CONTRACT NO. 1797

OHIO RIVER TUNNEL

ADDENDUM No. 5

All bidders bidding **Contract No. 1797** shall read and take note of this **Addendum No. 5**. The Contract Documents for **Contract No. 1797 – Ohio River Tunnel** are hereby revised and/or clarified as stated below.

O27-ST-143
ORT-O27-VD REINFORCEMENT PLANS
AND SECTIONS

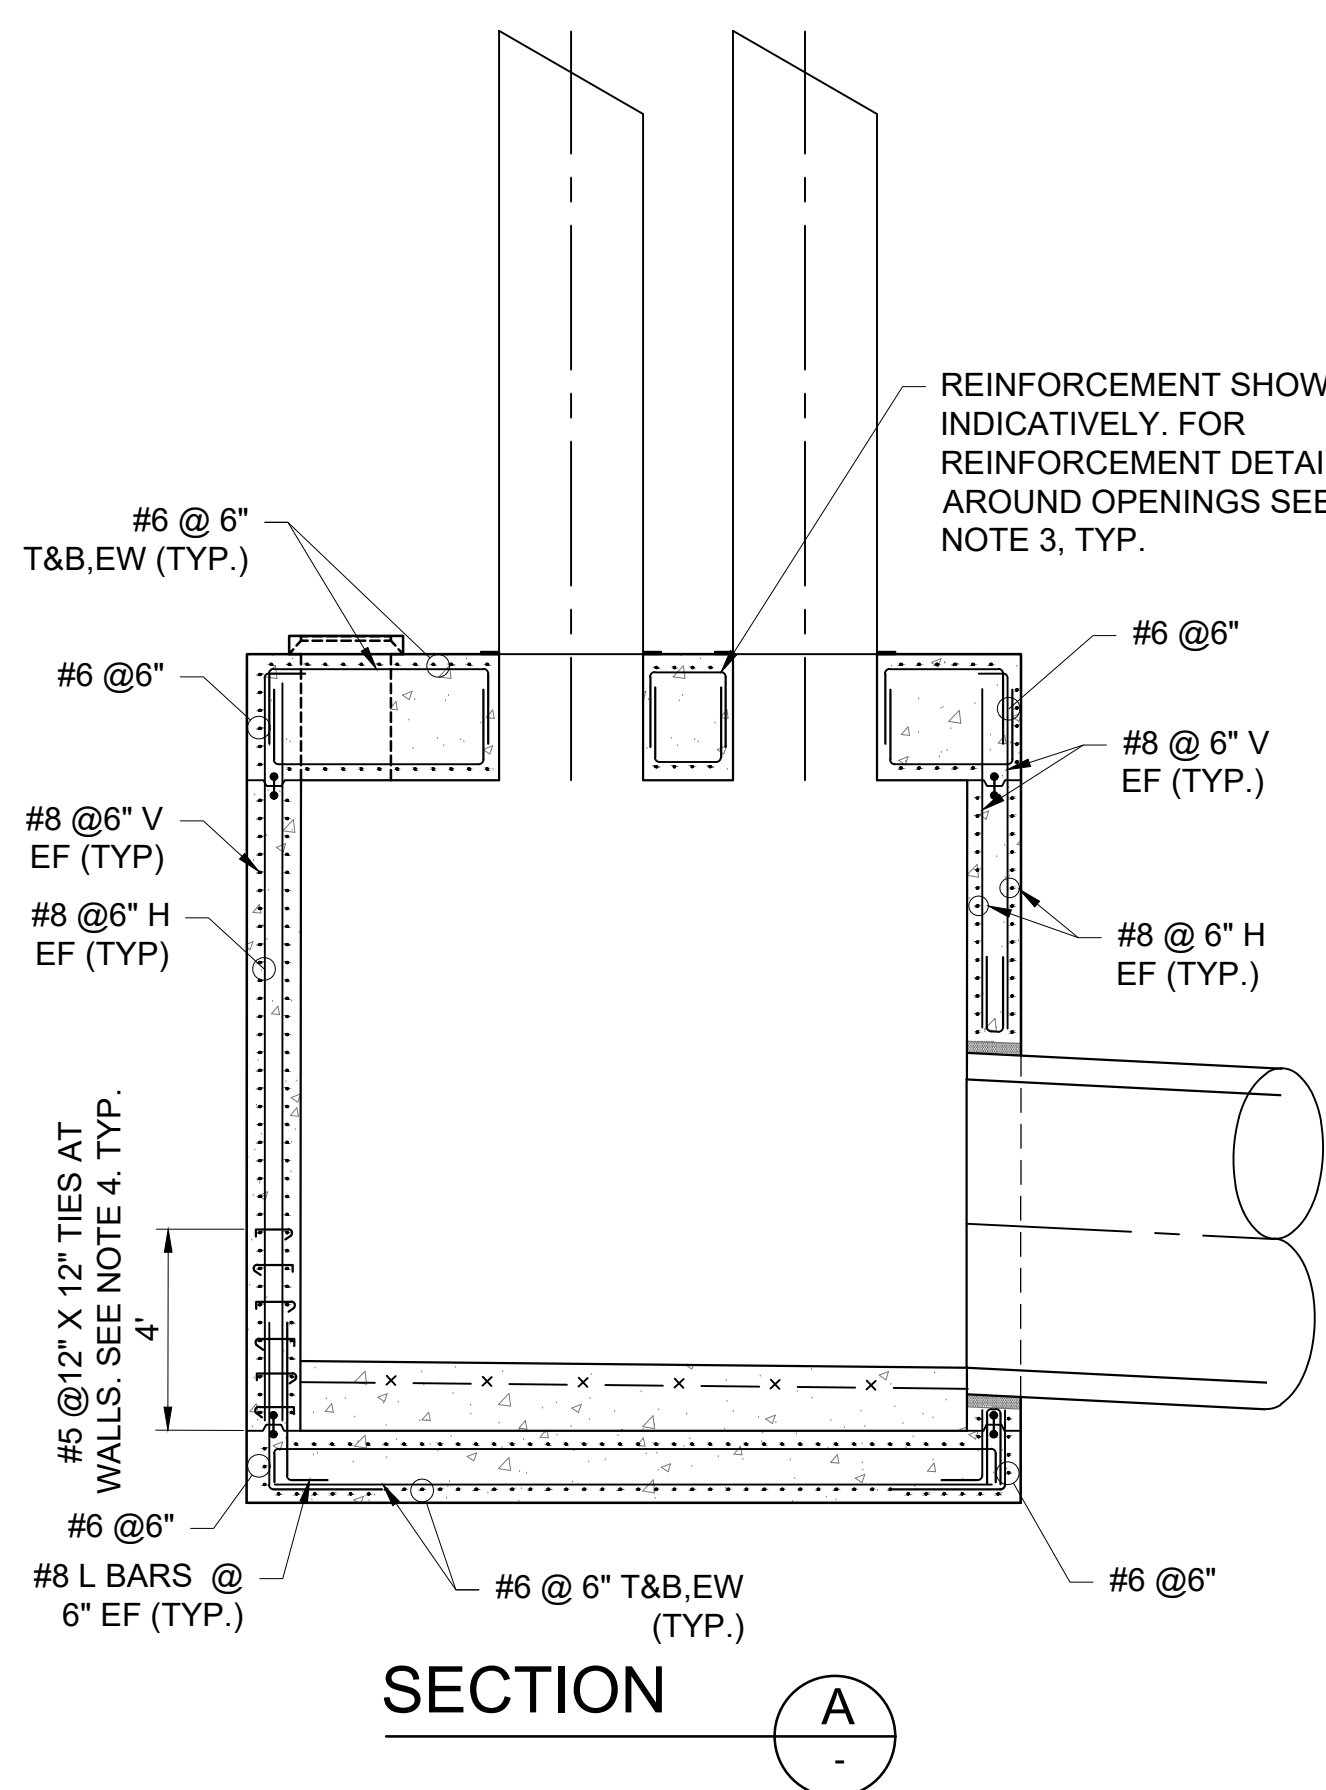
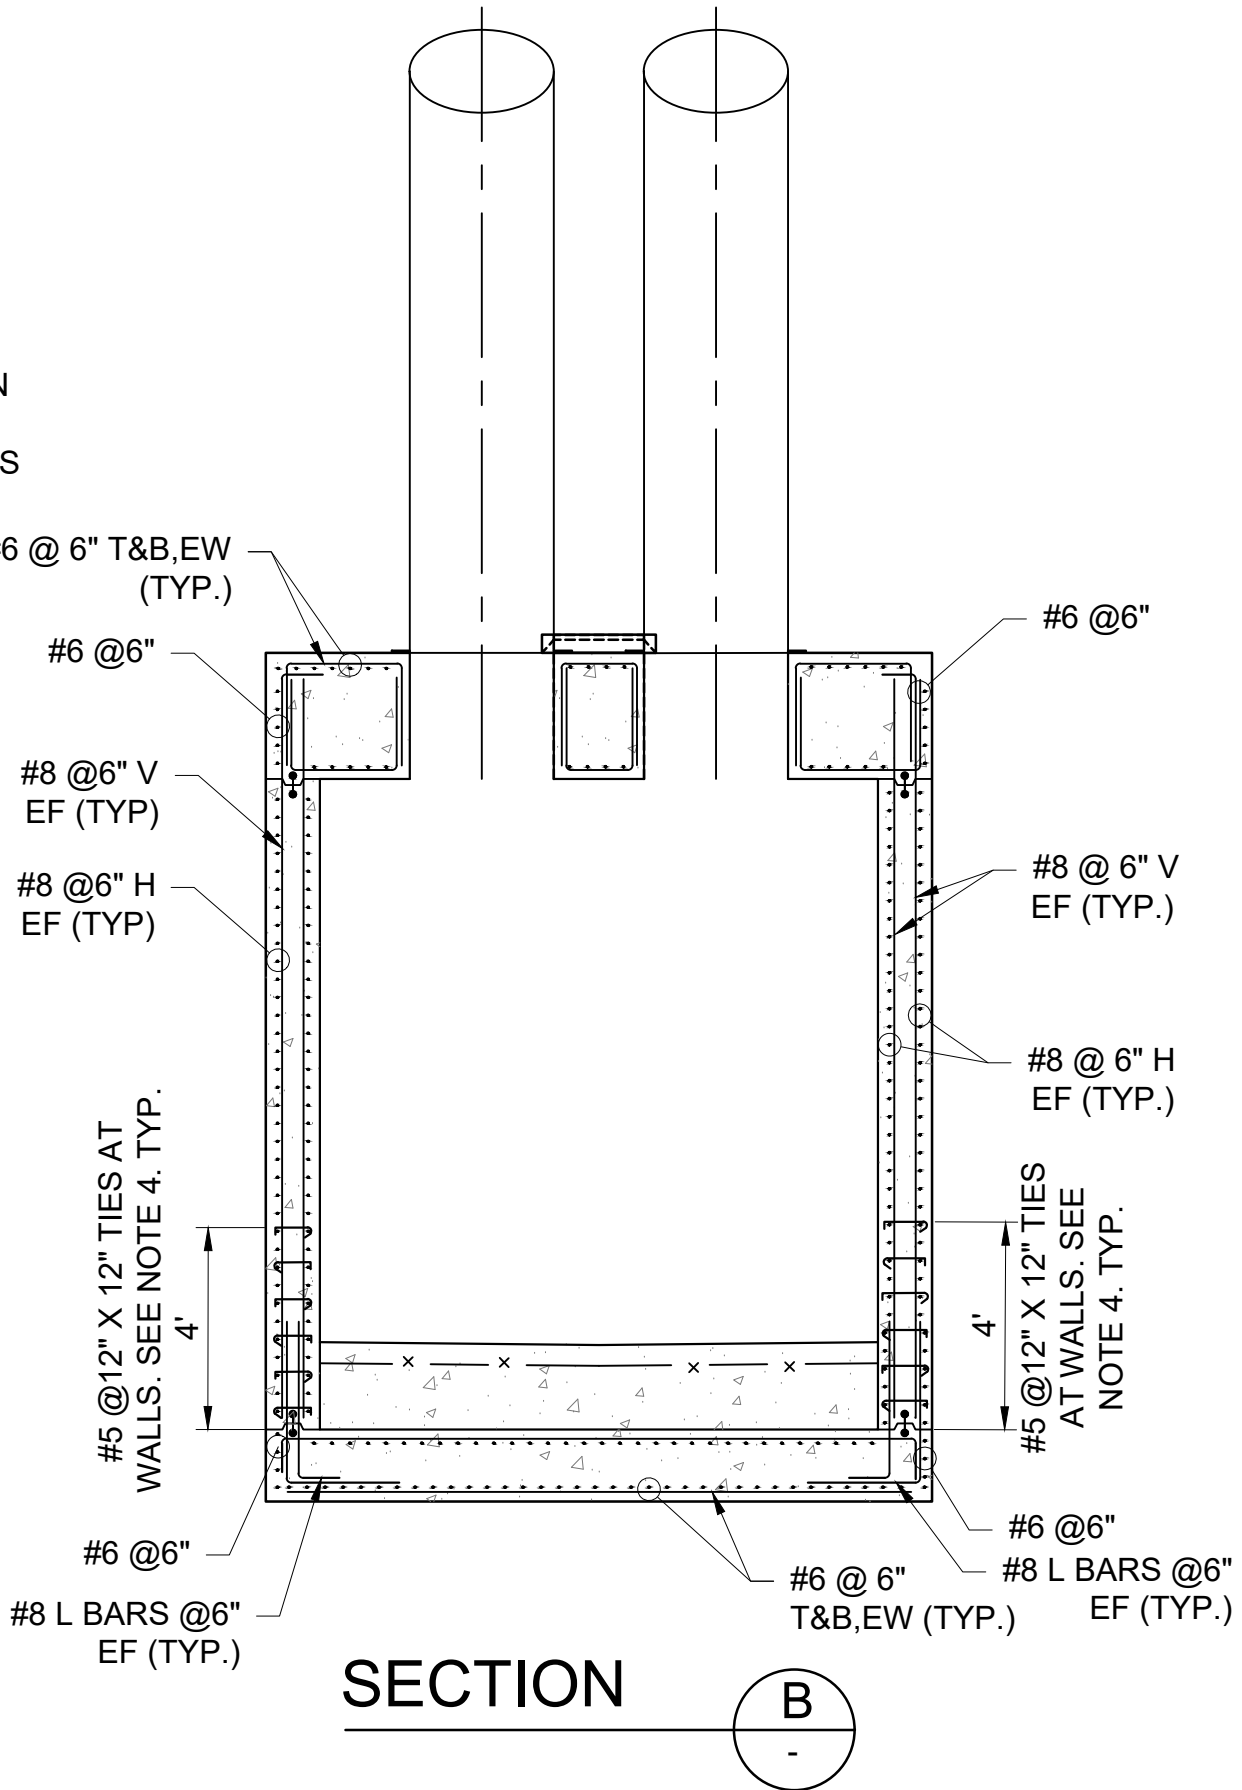
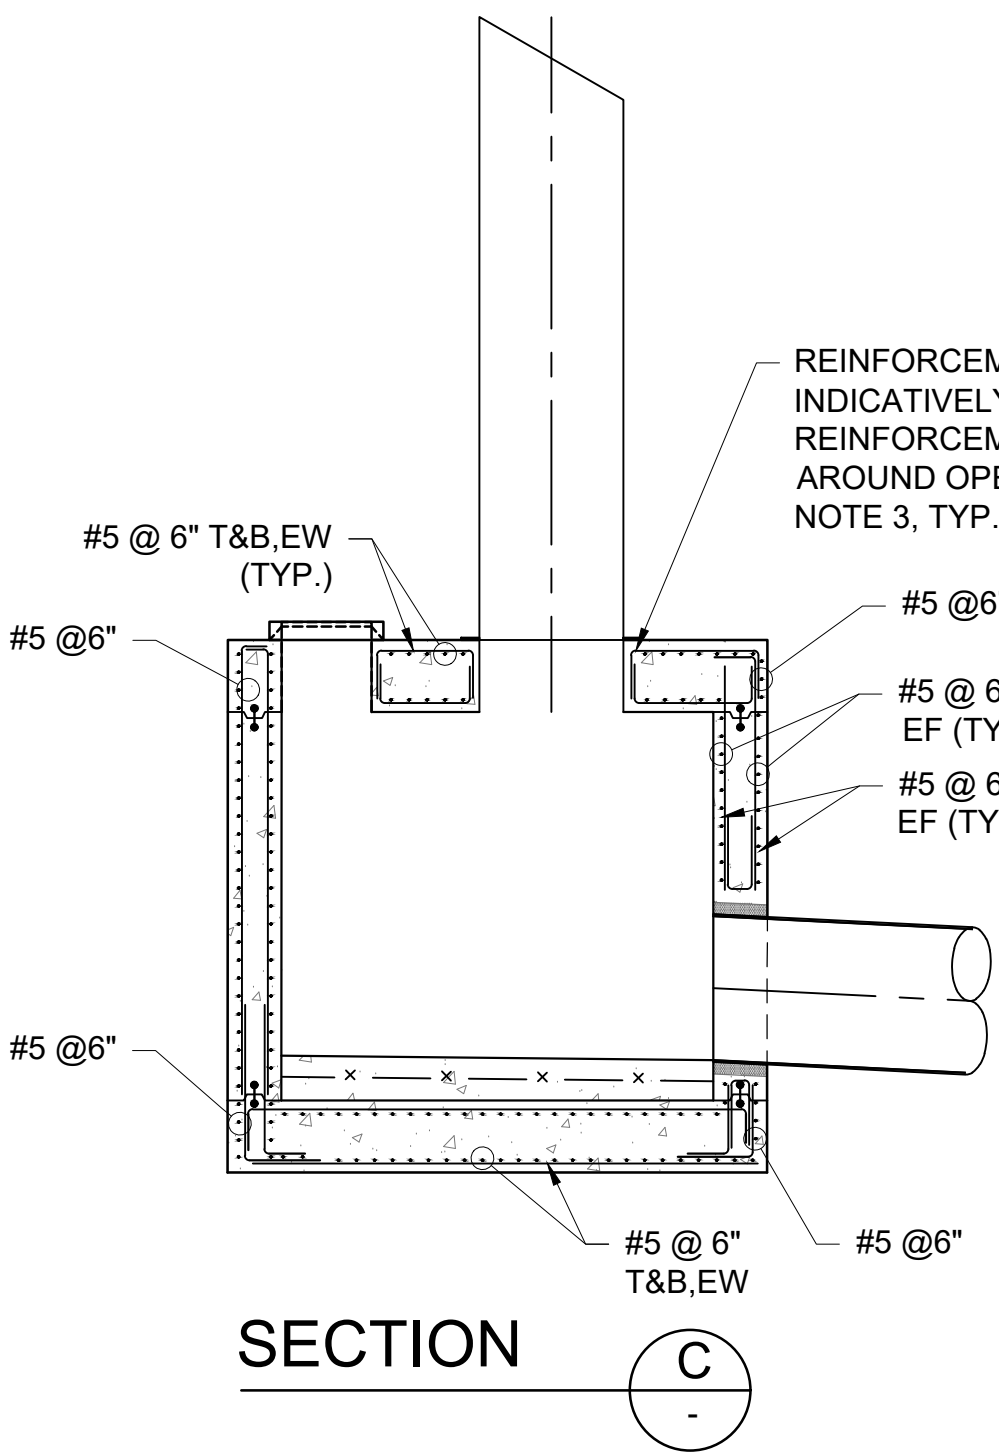
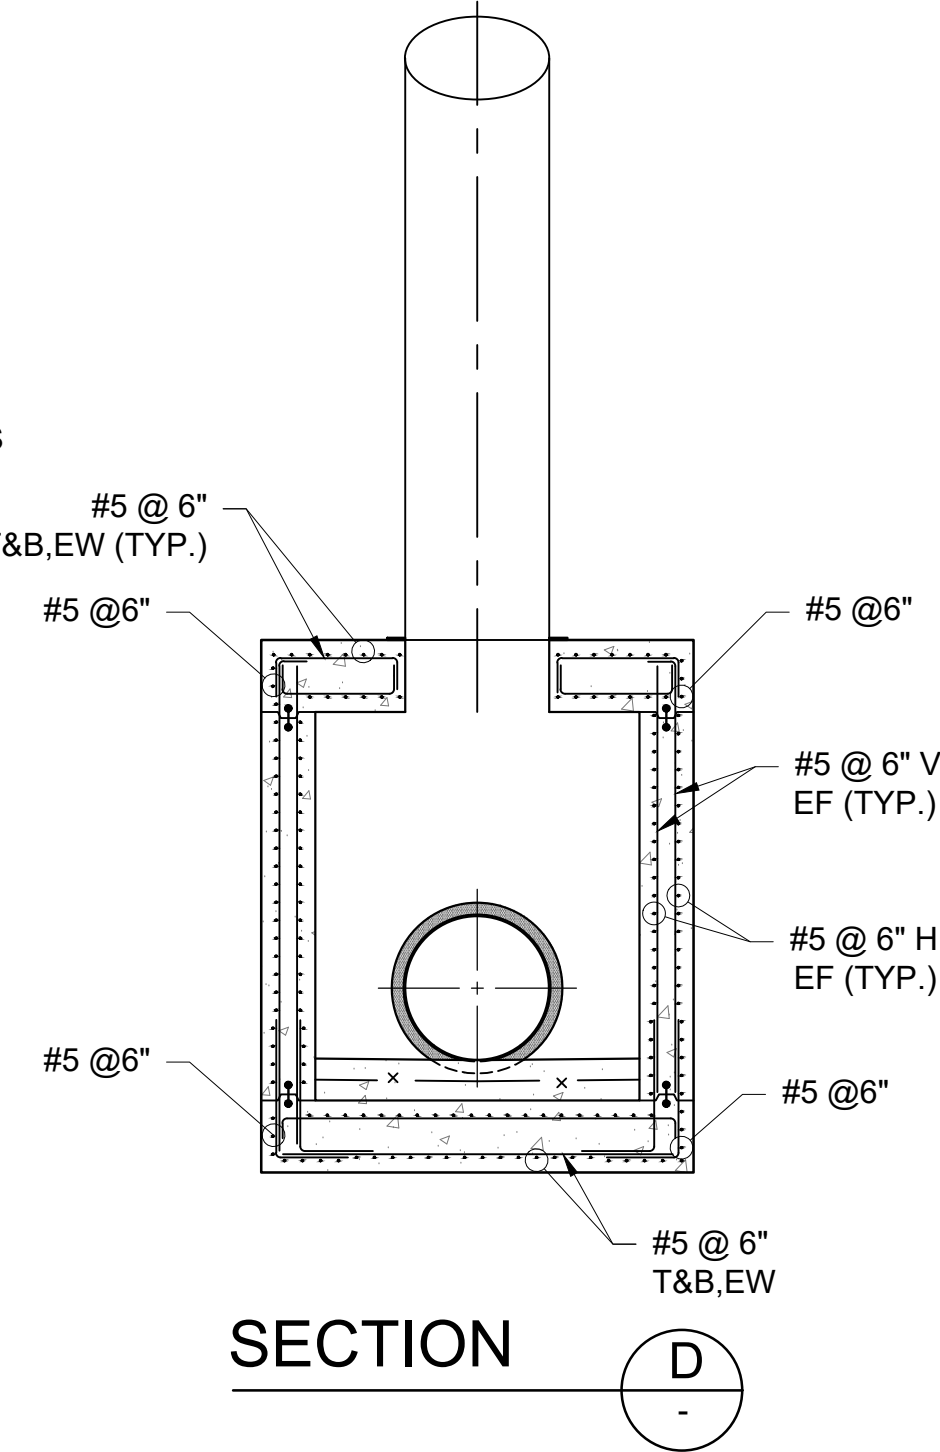
- A2 **This is a dedicated full-time position.**
- Q3 *Ventilation Diffuser SOE - For all sites that contain ventilation diffusers, a support of excavation design is to be designed by the contractor, and submitted to the owner for review and approved. The contract drawings reference in the support of excavation notes under note C, "Any excavation for the ventilation vaults deeper than 4 feet shall be supported by a temporary excavation support system without internal bracing or any elements of the SOE system intruding into the excavation footprint."*

- Please remove these internal bracing restrictions to allow the Contractor and their Engineer to determine the best solution for shoring these excavations.*

- A3 **Drawings O27-ST-142, O27-ST-143, O41-ST-226, A48-ST-315, A58-ST-438, A58-ST-440 O14-ST-628, O07-ST-713, O06A-ST-814, and O06A-ST-815 are revised and attached to this Addendum. See CHANGES TO CONTRACT DOCUMENTS section below and Attachment A of this Addendum.**

- a) DELETE O27-ST-142 (Sheet 245 of 770) and ADD Revised O27-ST-142 (Sheet 245 of 770), which is Attachment A to this Addendum.
- b) DELETE O27-ST-143 (Sheet 246 of 770) and ADD Revised O27-ST-143 (Sheet 246 of 770), which is Attachment A to this Addendum.

Designed by:	HTV	REV No.	DATE	REVISION	DESCRIPTION	APPV	PSK
Drawn by:	JMS	1	10/03/25		SOE NOTE UPDATE		
Checked by:	PSK
